EXPOSITION PARK MASTER PLAN

FINAL SUBSEQUENT ENVIRONMENTAL IMPACT REPORT (EIR)
TO THE LOS ANGELES MEMORIAL COLISEUM RENOVATION PROJECT EIR
(STATE CLEARINGHOUSE No. 1990011065)

SEPTEMBER 21, 2020

FIGURE 2.4.1-1
Proposed Master Plan Element 1 - Threshold and Gateway

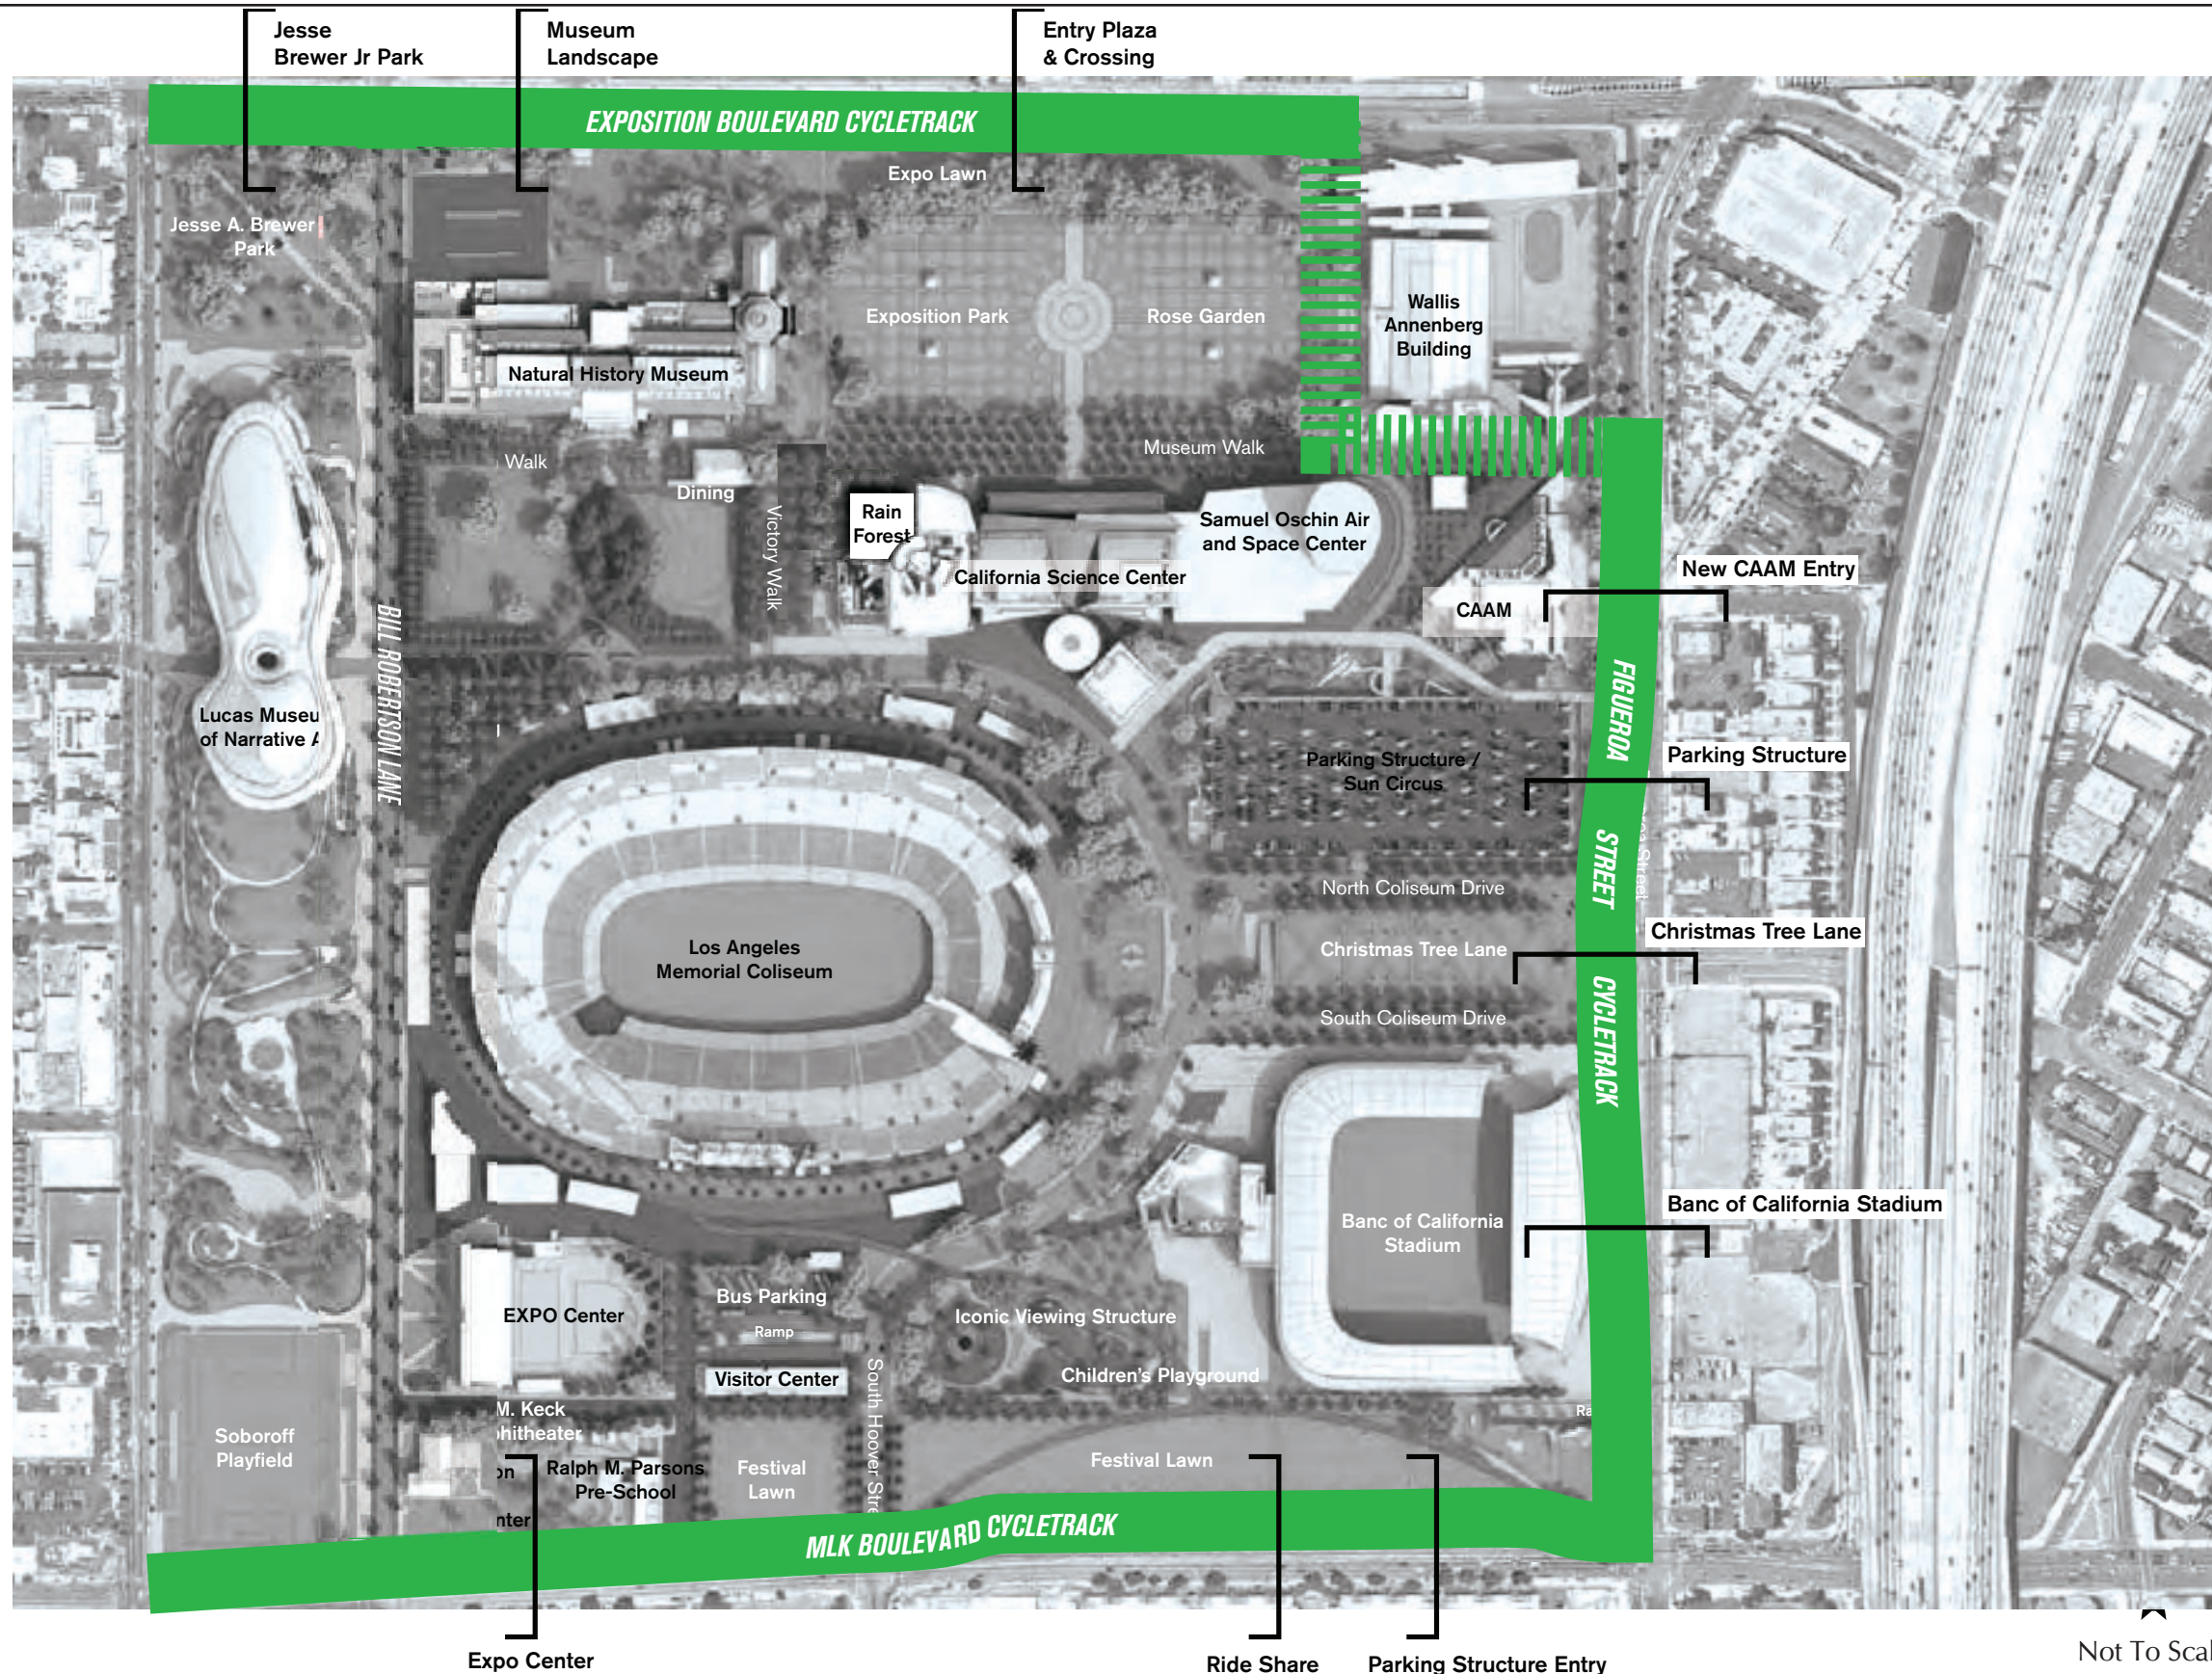
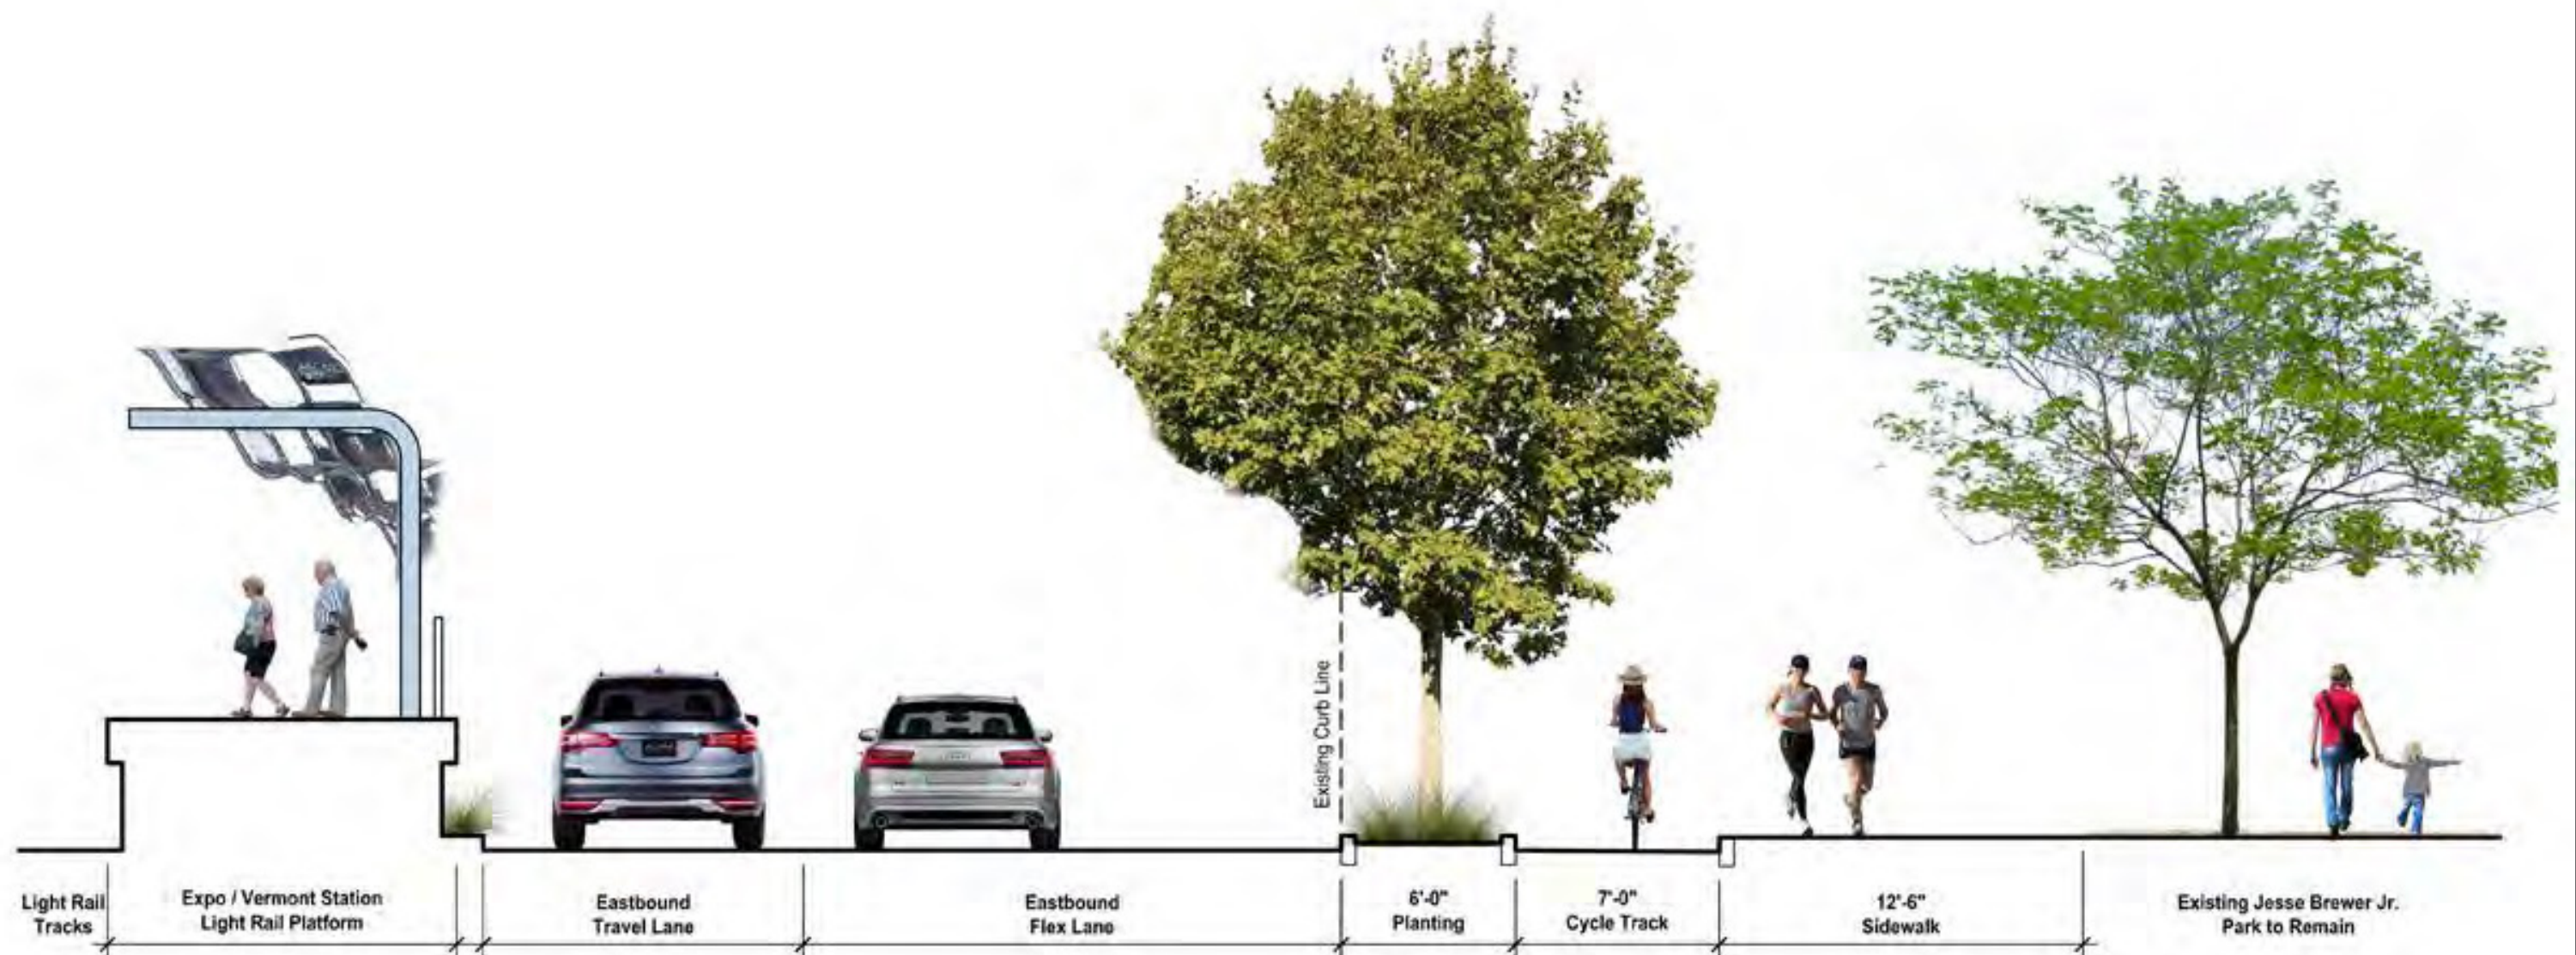
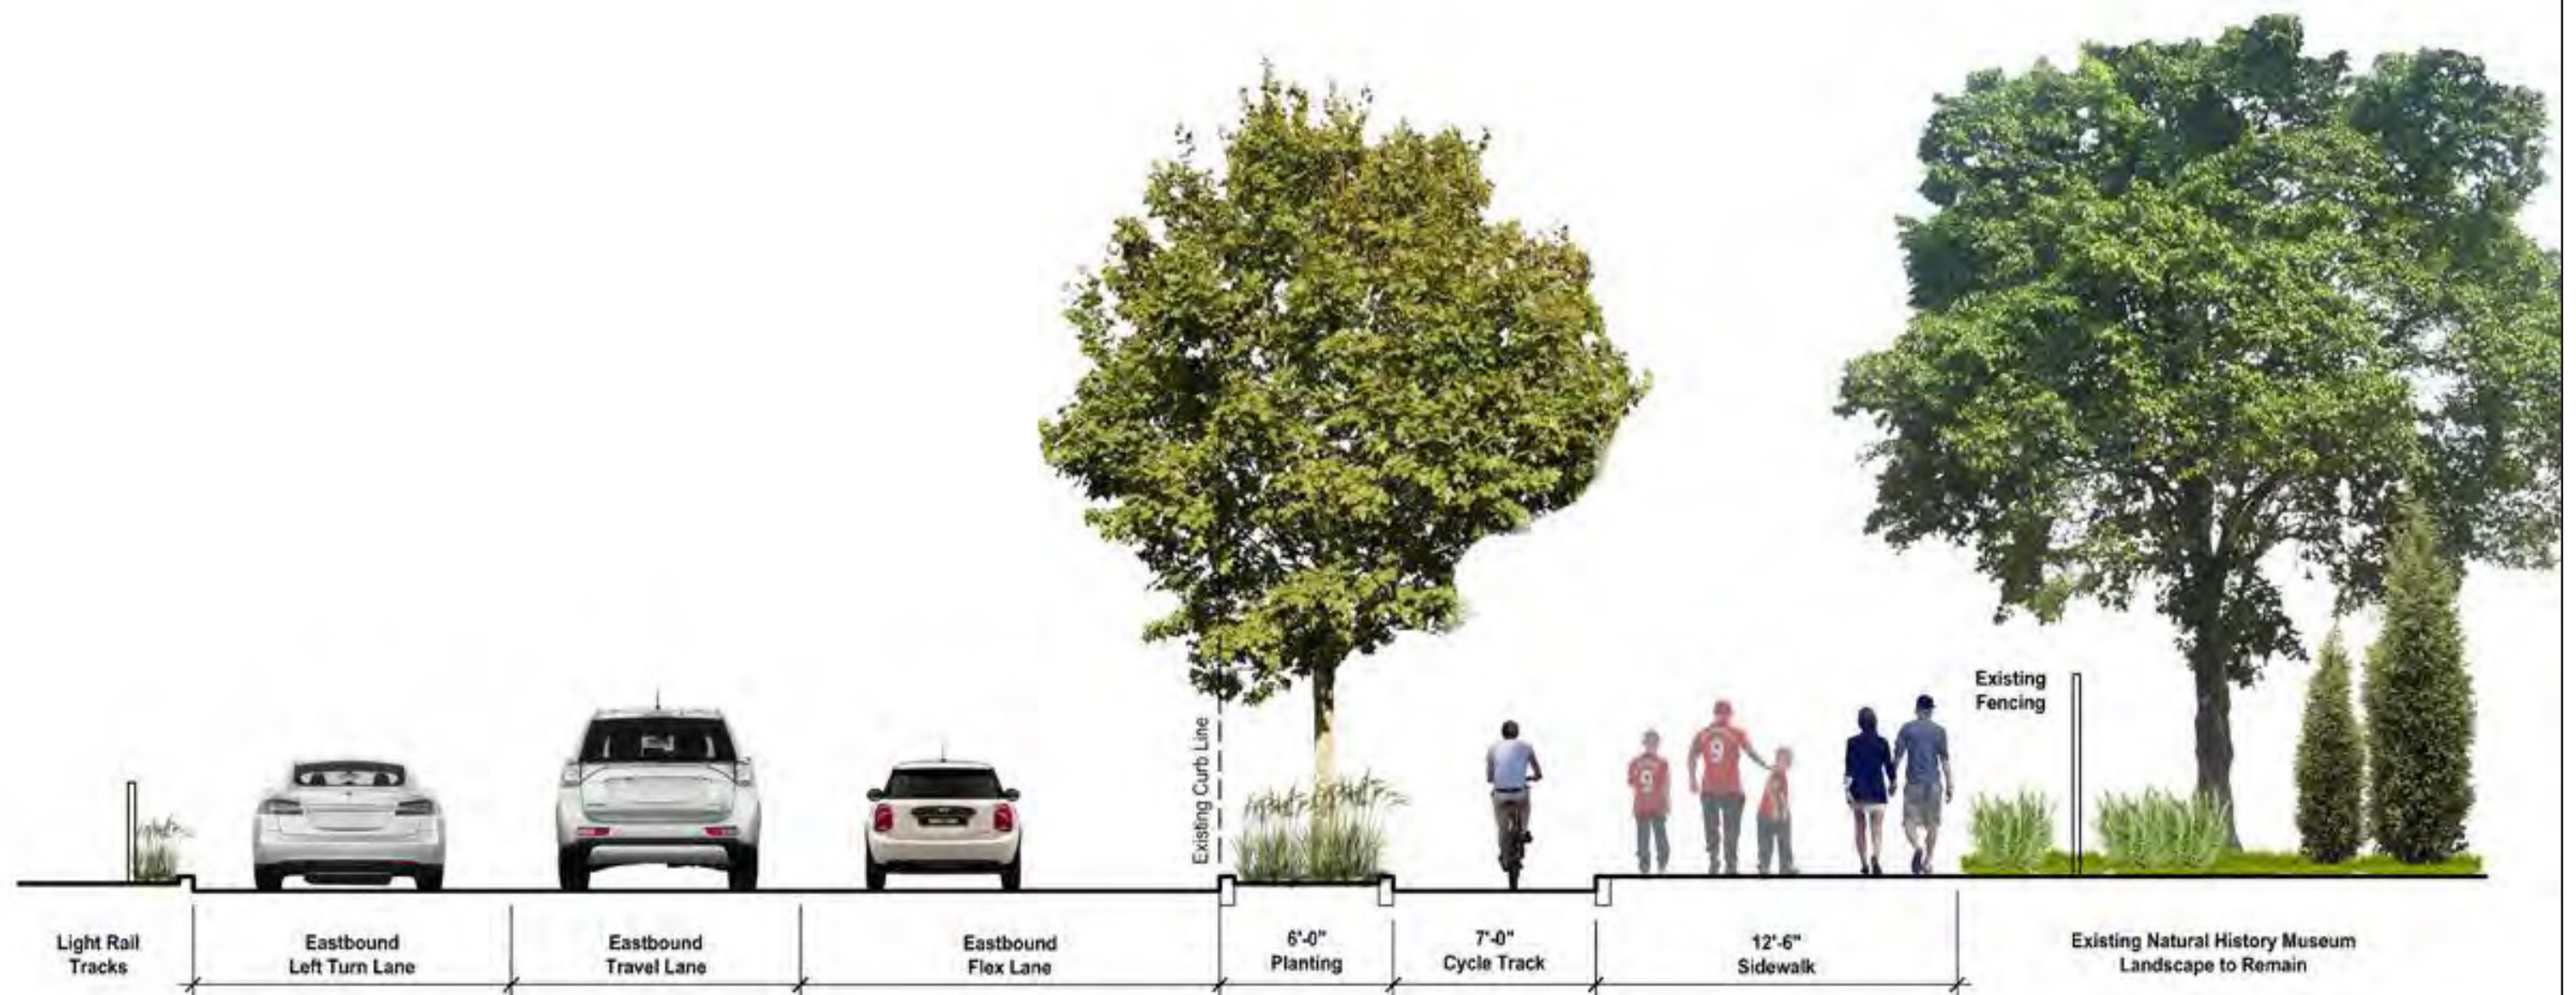
Page 2-10: Figure 2.4.1-1, *Master Plan Element 1 – Threshold and Gateway*, has been revised to provide further detail regarding the cycle track as well as safety issues on Kinsey Drive and State Drive.
